Release Fractions in Non-LOCA Accidents in Draft Regulatory Guide 1.183 DG-1199

N. C. Andrews, R. O. Gauntt
Sandia National Laboratories
P.O. Box 5800, MS 0748

In this note, an argument is made that the non-loss of coolant accident (LOCA) fractions of fission product inventory found within the gap is too high for alkali metals as currently specified within Regulatory Position 3.2 of Draft Regulatory Guide 1.183 rev.1 (DG-1199). This assertion extends to the enthalpy-dependent transient fission product release component used in reactivity initiated accidents.

Figure 1. Predicted Release Fraction for Kr-85 (Long-Lived) Isotope as a Function of Burnup Illustrating Peak Release Occurs Near EOL (Figure 2.5 in PNNL-18212 rev. 1)

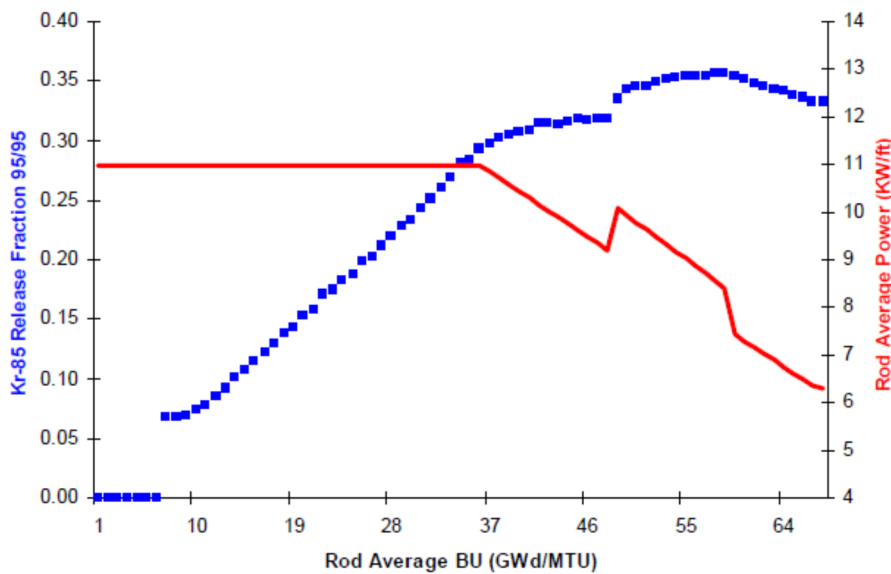
The higher values of Kr-85 release in DG-1199 can be attributed to higher burnups that needed to be considered in order to create a bounding case for the regulatory guide. It can be seen that at high burnup the predicted release fraction for Kr-85 increases to a peak near a rod-average burnup 55 MWd/kgHM. This can be seen in Figure 1.

Per the technical basis document, this Kr-85 release was calculated using the fuel performance code FRAPCON 3.3 with associated uncertainties. Alkali metals release-to-birth ratios, unlike those for noble gases are not calculated directly by FRAPCON. Instead, scaled releases are estimated using Equation 1 and Equation 2. (PNNL-18212 Rev. 1)

Tying alkali metal (and Cs) release directly to Kr-85 release leads the release of cesium to be extremely high relative to other known measurements of Cs release behavior from experiments. Moving from DG-1081 to DG-1199, the alkali metal release fraction increased by nearly a factor of four, from 0.12 to 0.50. It is believed that an increase this large without a justification that is based on cesium-specific data does not reflect current understanding and could be excessively conservative.

It is recommended that in lieu of scaling the cesium release with Kr-85 a physics-based or empirical data-based chemical transport model for cesium release be used. Should the cesium release be calculated based on the release of a noble gas, it is recommended that the cesium release be based on that of xenon and not krypton. Xenon is included in the “other noble gases” listed in Tables 1, 2 and 3.

Figure 2: Burnup-Dependent Transient FGR Correlations. Open symbols indicate non-failed, solid symbols indicate cladding failure. (Clifford, 2015)

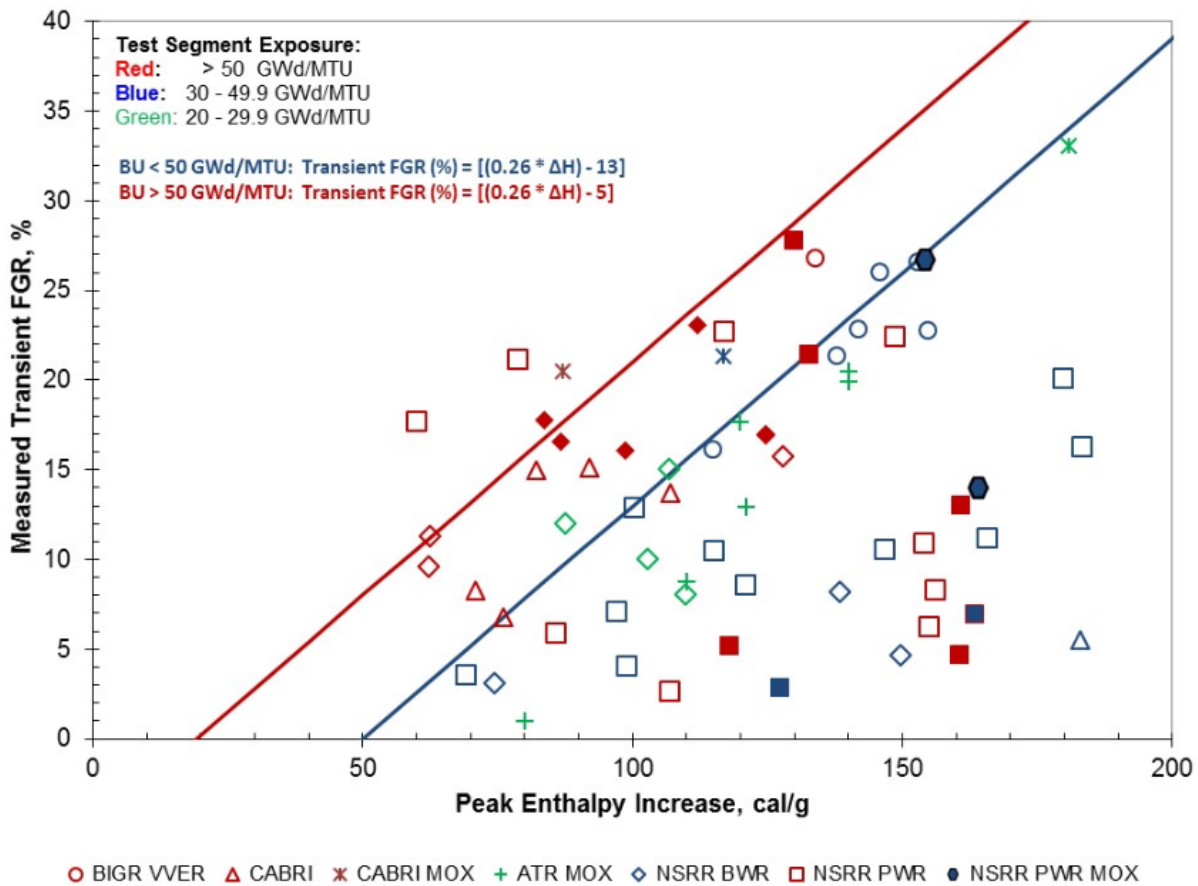
New regulatory guidance within Clifford (2015) indicates that a revision of the fragmentation-induced fission gas release fractions found within Table 4 of DG-1199 requires an update. (See Table 2 of this note.) This update is only pertinent to reactivity insertion accidents, and hence only applies to Table 4 of the document. Within Clifford (2015) new experimental data is presented and proposed changes to the fragmentation-induced factors are made. It is recommended that these changes be implemented within DG-1199. Specifically, it is recommended that the “Kr-85” and “Other Noble Gas” entries of Table 4 in DG-1199 be

These two separate correlations follow the experimental data closely, as can be seen in Figure 2, where both are applied against multiple data sets for different reactor and fuel types.

Peak Pellet Burnup ≥ 50 GWD/MTU:

Kr-85: $((0.38) + (0.0022 * \Delta H)) \rightarrow ((0.38) + (0.0026 * \Delta H - 0.05))$
 Other Noble Gases: $((0.084) + (0.00073 * \Delta H)) \rightarrow ((0.084) + (0.0026 * \Delta H - 0.05))$
 Alkali Metals: $((0.50) + (0.0031 * \Delta H)) \rightarrow ((0.084) + (0.0037 * \Delta H - 0.07))$

Peak Pellet Burnup < 50 GWD/MTU:

Kr-85: $((0.38) + (0.0022 * \Delta H)) \rightarrow ((0.38) + (0.0026 * \Delta H - 0.13))$
 Other Noble Gases: $((0.084) + (0.00073 * \Delta H)) \rightarrow ((0.084) + (0.0026 * \Delta H - 0.13))$
 Alkali Metals: $((0.50) + (0.0031 * \Delta H)) \rightarrow ((0.50) + (0.0037 * \Delta H - 0.18))$
